BRITISH GLIDING ASSOCIATION

Technical Newsheet. TNS 11/82

<b>TITLE</b> T65 'VEGA' Central Elevator Hinge on Tailplane, Elevator Tongue & Pivot Bearings for Elevator Rocker Arm.	<b>T.I.No.</b> 104/T65 Iss.1
<b>CLASSIFICATION</b> C.A.A. Mandatory	
<b>COMPLIANCE</b> Inspection to be carried out before the next flight unless LTO 'Elevator & Canopy Jettison Mechanism', 20th August has been carried out.	
<b>OBJECTIVE</b> To ensure structural integrity of the central elevator hinge on tailplane elevator drive tongue and to inspect the pivot bearings for the elevator rocker arm assy. Also to reinforce central elevator hinge on tailplane.	
<b>JUSTIFICATION</b> Cracking and a lack of stiffness has occurred in the area 'A' (Fig 1), the cause of which is attributable to heavy landings and/or excessive bearing loads during elevator assembly.	
<b>APPLICABILITY</b>  All Slingsby T65A, C, D gliders, including spare tailplane/elevators expanding on CAA Airworthiness Directive No.008-08-82. (LTO 'Elevator & Canopy Jettison Mechanism', 20th August).

TITLE		T65 'VEGA' Canopy Jettison Mechanism	T.I. No. 105/T65
CLASSIFICATION C.A.A. Mandatory			
COMPLIANCE Inspection to be carried out before next fl

FIG 1 Area of Cracking on Vega T-Plane

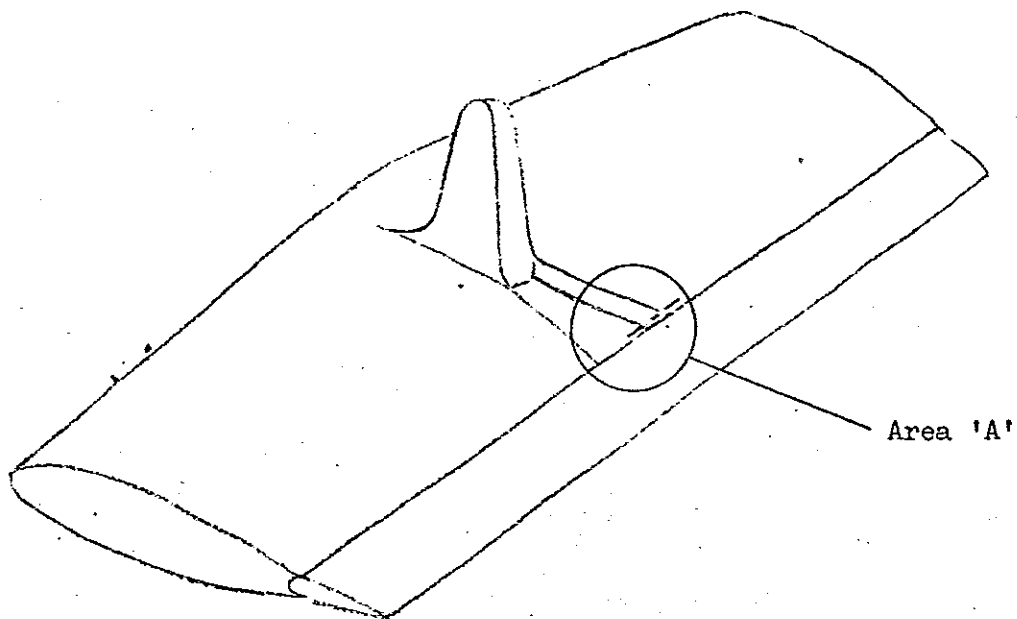
1.3 Inspect the tailplane centre hinge pin mounting rib at the section just forward of the hinge pin as detailed in Fig 6. If cracks or damage are found a repair entailing the fitting of a new 'reinforced' rib will be required. The repair scheme is detailed in Section 4 and should be undertaken by S.A.L. or an approved repair shop. If the section does not show signs of cracking a reinforcement cloth will be required as detailed in Section 5. Alternative means of repair for minor cracking may be carried out with the agreement of SAL.  <u>Note</u> - Use Epikote 162/Epikure 113 resin system throughout.	
<b>ISSUED BY:</b>  <div style="text-align: center; font-size: 1.5em; font-family: cursive;">B Mellors</div>	<b>Date</b> 22nd Sept 82
for and on behalf of <b>SLINGSBY ENGINEERING LIMITED</b> <small>Kirkbymoorside, York YO6 6EZ, England. Tel. 0751 31751 Telex 57911</small>	<b>Page</b> 1 of 6

FIG 2 Reinforcement of Elevator-Tongue

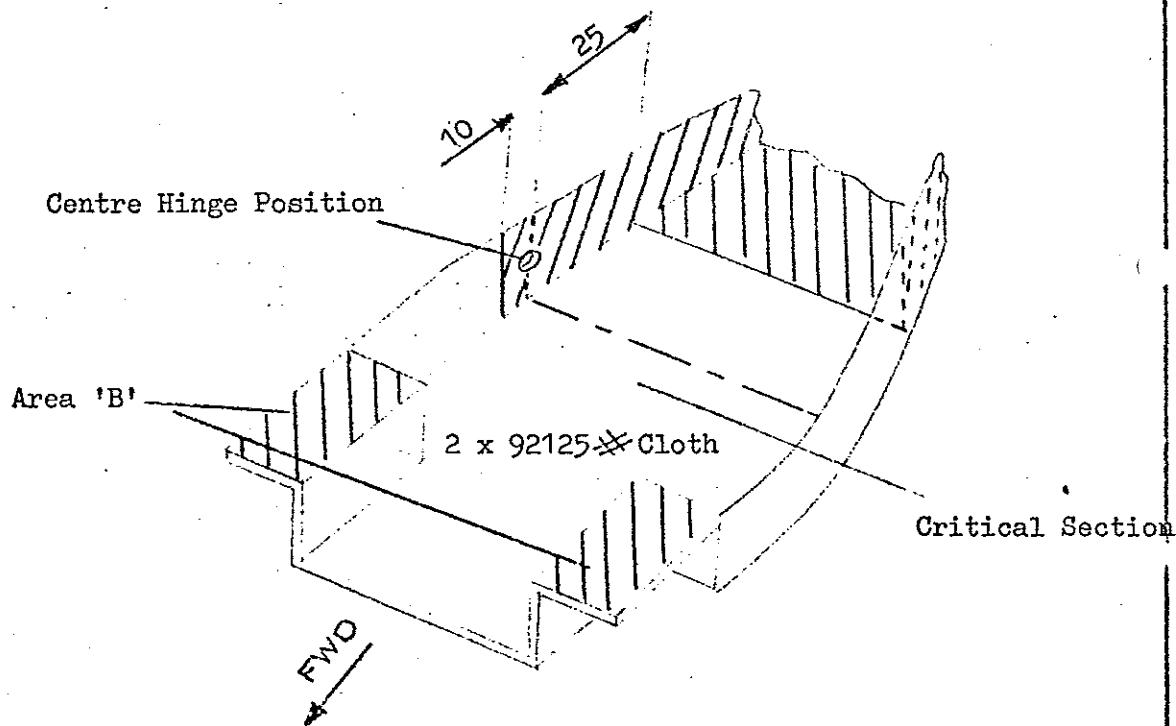
- 2.1 Rectification of lack of stiffness of the elevator tongue will be as follows :-
- (a) Remove the tailplane/elevator assembly from the aircraft.
  - (b) With the elevator removed from the tailplane, abrade the tongue of the elevator over the area detailed in Fig 2.

- (c) Layup 2 layers of woven roving cloth (2 x 92125~~XX~~) over the area detailed in Fig 2.
- 3.1 If the pivot bearing 04 DU 04 is worn it may be replaced as follows (refer Fig 3).

- (j) When fitting the tailplane elevator assembly ensure the elevator tongue seats correctly on the actuator. If there is a clearance between the tongue and actuator the tongue must be built up in the Area 'B' detailed in Fig 2. If there is a foul between the tongue and actuator, the tongue must be trimmed (refer Area 'B' Fig 2) to seat properly on the actuator. Build up the cloth under the flanges and around the web to compensate for any cloth removed.

Only layup cloth on the inside of the tongue on the area NOT shaded.

FIG 3 Actuator Pivot Bearing

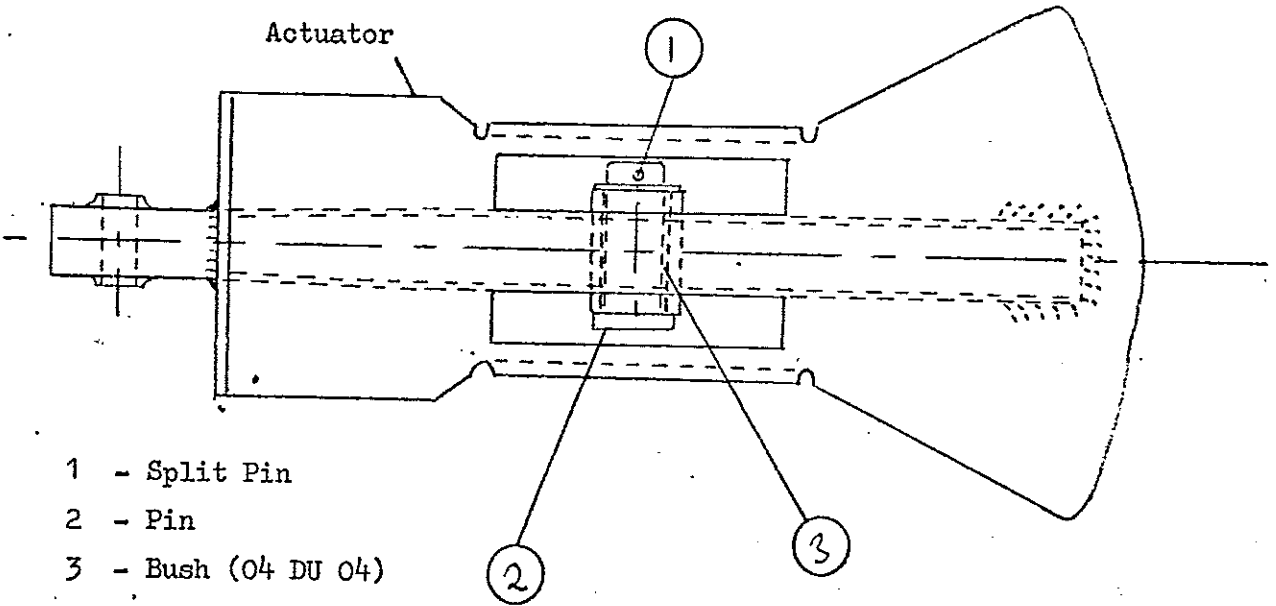
- (a) Remove the tailplane/elevator assembly from the aircraft.
  - (b) Remove the split pin (Item 1) and washer from the central hinge of the actuator (located on top of fin).

- (c) Remove pin (Item 2).
  - (d) Disconnect the pushrod on the fwd end of the actuator (similar to above).
  - (e) Drift the bush from the elevator actuator assembly and replace with new bush (04 DU 04), available from S.A.L.

FIG 4 View of Central Section of T.Plane with the top skin removed.

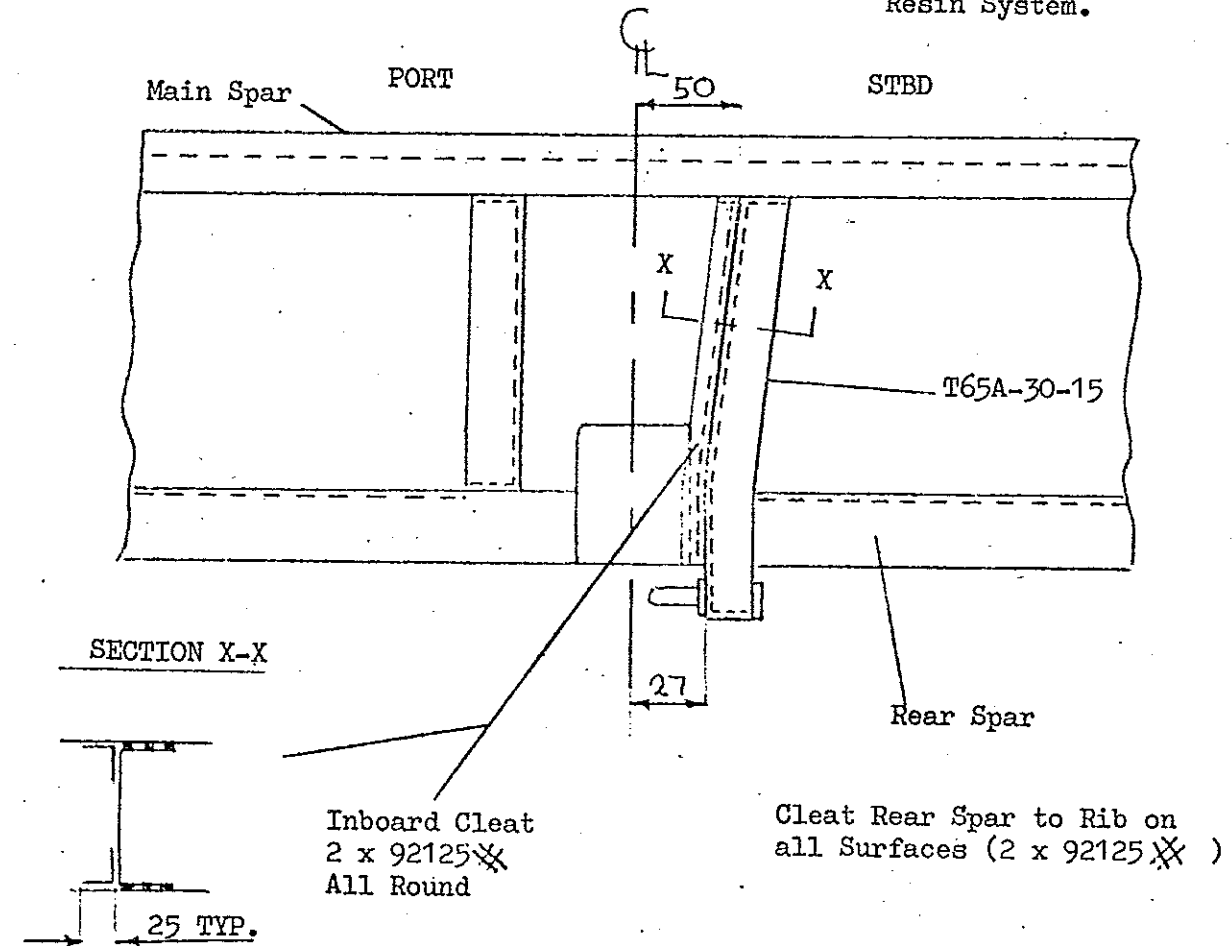
- (f) New split pins must be fitted when reassembling.
- 4.1 Replacement of the central tailplane rib with reinforced rib only available from S.A.L. will be carried out as follows (Refer Fig 4).

- (e) Coat the rib with glassflock and initially position the rib to the dimensions detailed in Fig 4.
  - (f) Position the tailplane in tressles as shown in Fig 5.

- 4.1 (g) Fit the elevators checking the split pin hole is accessible. The rib should now be correctly positioned.
- (h) Carefully remove the elevators and apply the cleat cloths as detailed in Fig 4.

Use Epikote 162 Epicure 113  
 Resin System.

FIG 5 Positioning of Elevators

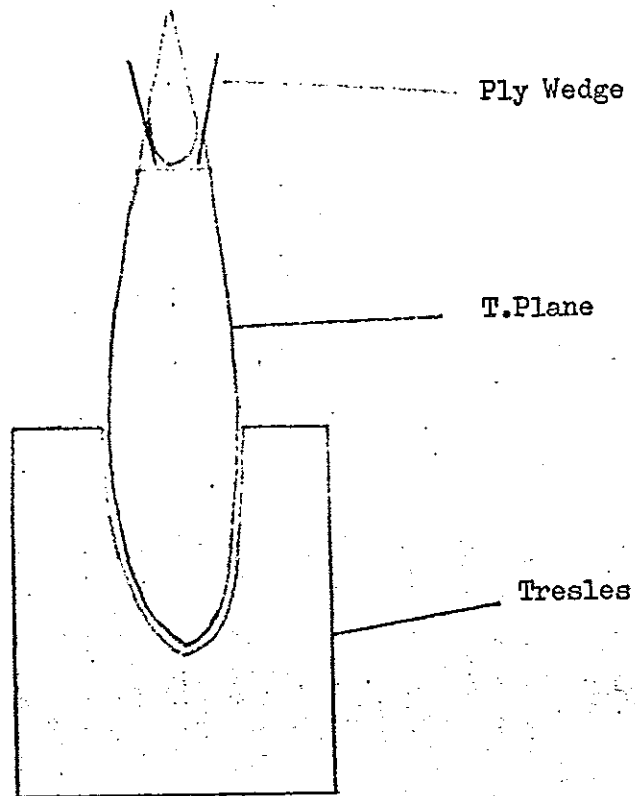
- (i) The elevators should now be repositioned to ensure the rib is still located in the correct position. The elevators should be pushed fully home again ensuring the split pin hole is accessible. Position wedges as shown in Fig 5 to hold the elevators in the neutral position.

FIG 6 Reinforcement Cloth on the Centre Tailplane Hinge

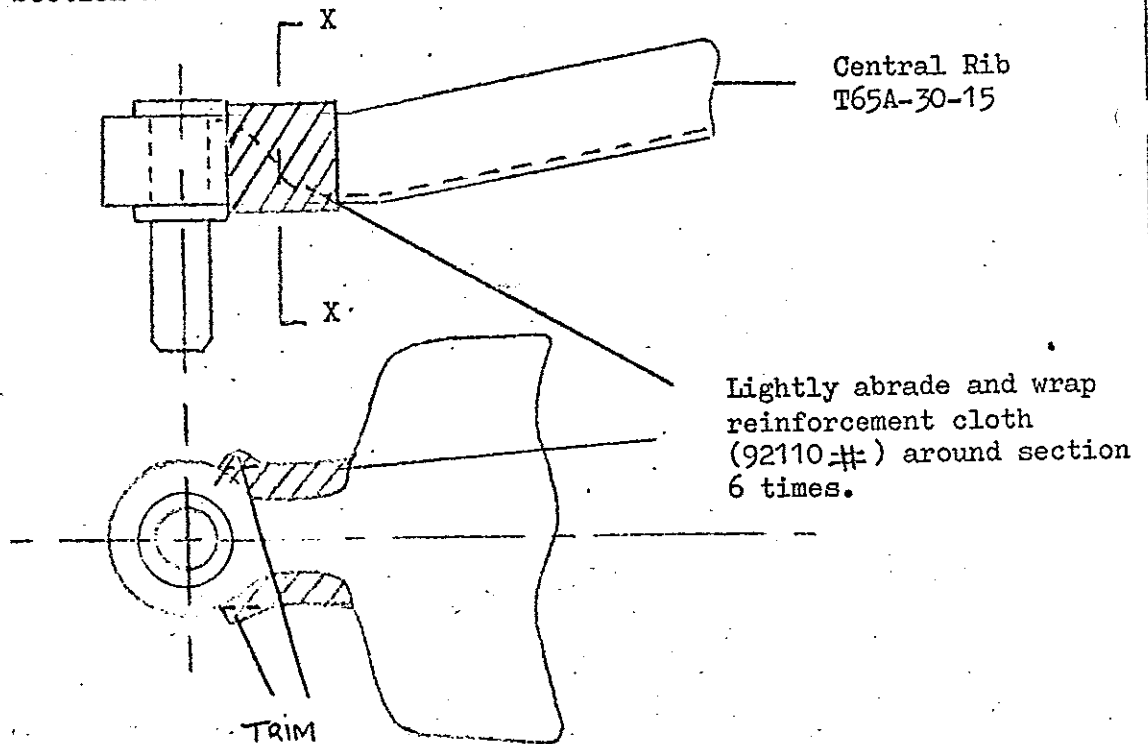
- (b) When the elevator is removed from the tailplane, lightly abrade the area shown in Fig 6.
- (c) Wrap a 10mm strip of 92110# woven roving cloth 6 times around the area detailed.

Inspect Section X-X

FIG 1 T65 Canopy Jettison Mechanism

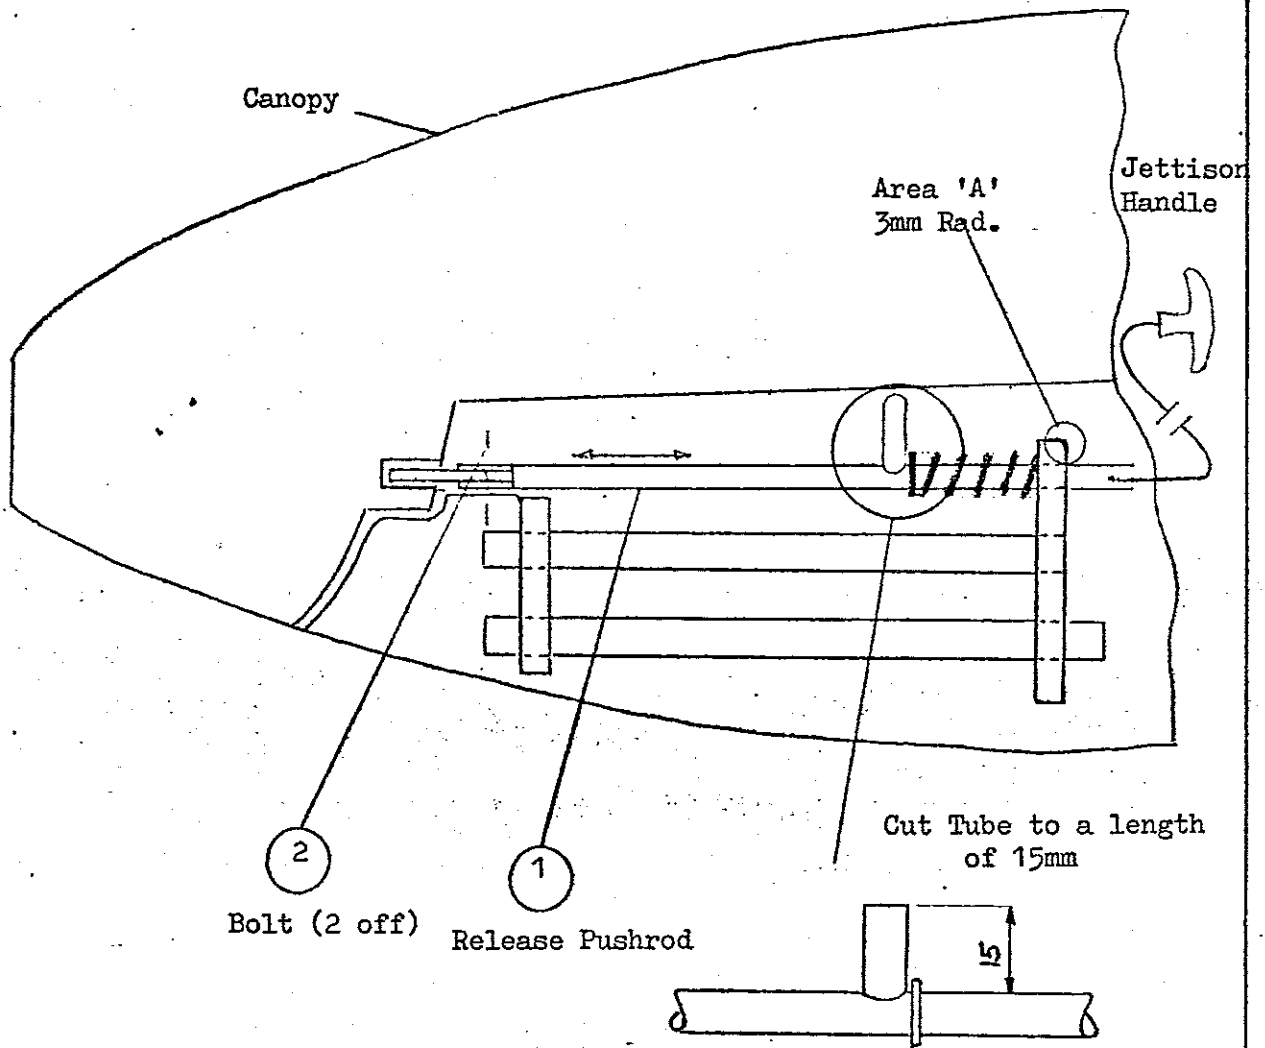
1.1	Remove the canopy from the fuselage.		
1.2	Ensure the two bolts (indicated in Fig 1, Item 2) are tight.		
1.3	Inspect the front portion of the release pushrod (Fig 1, Item 1) and ensure the pushrod is not bent. The release pushrod should slide easily through the guides by pulling on the canopy jettison handle.

2.	Before further flight modify, and check the operation of the canopy release mechanism as follows :-		
2.1	Cut the tube on the release pushrod to a height of 15mm (refer Fig 1).

2.2	Paint a white line on the canopy arm marking the position of the tube (Fig 1) on the release pushrod in the locked position.		
PARTS REQUIRED			
ISSUED BY:		Date 22 Sept 82	
for and on behalf of		Page 1 of 4	
<p align="center"><b>SLINGSBY ENGINEERING LIMITED</b> Kirkbymoorside, York YO6 6EZ, England. Tel. 0751 31751 Telex 57911</p>

FIG 2

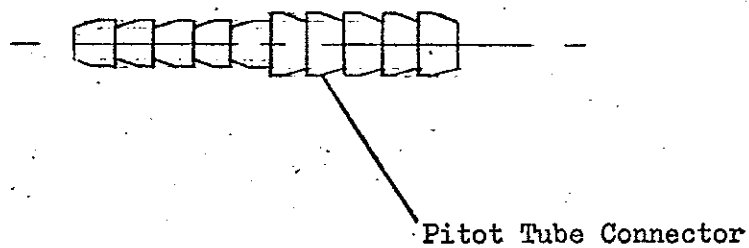
- 2.3 For the canopy to jettison, the pitot tube must disconnect relatively easily from the instrument panel. Therefore the connector must not have the tubes wired or retained in any manner, but only have the pitot tubes pushed into position, utilising a connector similar to that shown in Fig 2.
- 2.4 The canopy hinge beam may require the area 'A' (Fig 1 & Fig 3) to be filed away giving a smooth radiused profile to prevent a foul occurring when the canopy is jettisoned.
- 2.5 With the canopy in the closed position and locked, pull the canopy jettison handle and simultaneously lift the canopy at the fwd end. The canopy should now lift off hinging about the aft latching point.

FIG 3

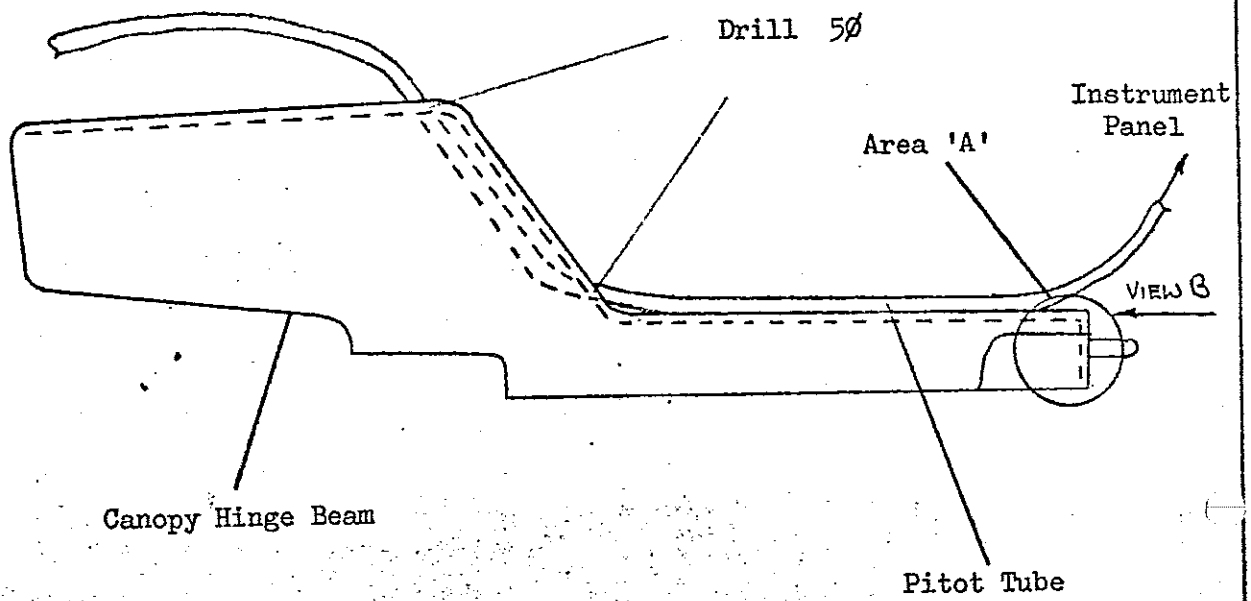
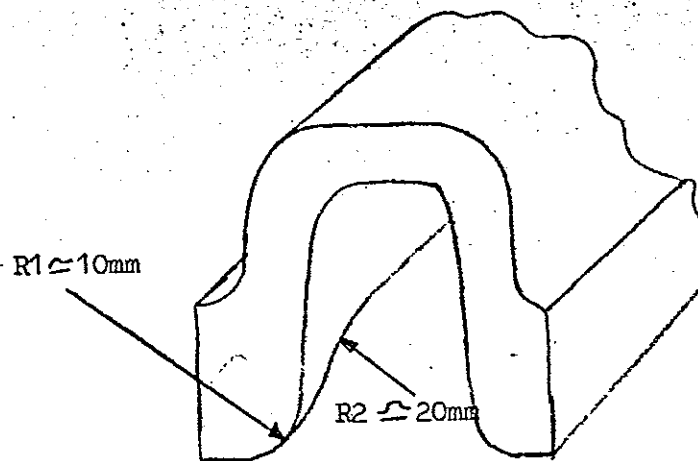
1.4	Inspect the pitot tube for damage where the tube is routed under the channel sectioned arm of the canopy. If damage is apparent replace the pitot tube and re-route the tube on the outer surface of the channel securing the tube as previously (refer Fig 3).

Radius the corners (R1 & R2)
